UNITED STATES PATENT AND TRADEMARK OFFICE

APPLICATION NO.	FILING DATE	FIRST NAMED INVENTOR	ATTORNEY DOCKET NO.	CONFIRMATION NO.
10/010,149	11/12/2001	Robert F. Evans	FCI-2580/C2977	7215

Office Action Summary

DETAILED ACTION

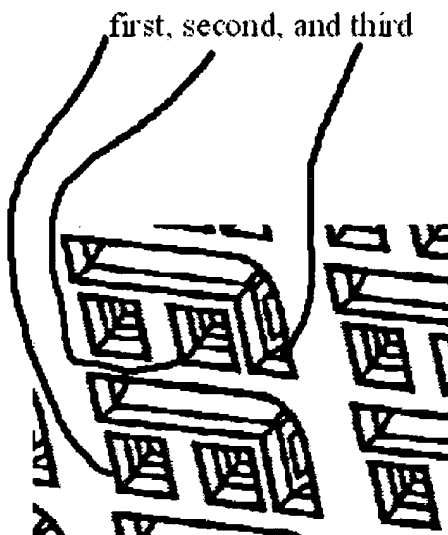
-- In reference to claim 21, Kline shows (cover sheet)

the plurality of receptacle contacts 24 are substantially cylindrical shaped.

-- In reference to claim 22, Kline shows ((cover sheet) and (figure 6) the plurality of receptacle contacts are arranged into an array of rows and columns.

-- In reference to claim 23, Kline shows (see examiner's figure) the columns are arranged in repeating patterns of first, second, and third columns and the first and second columns are spaced farther apart than the second and third columns.
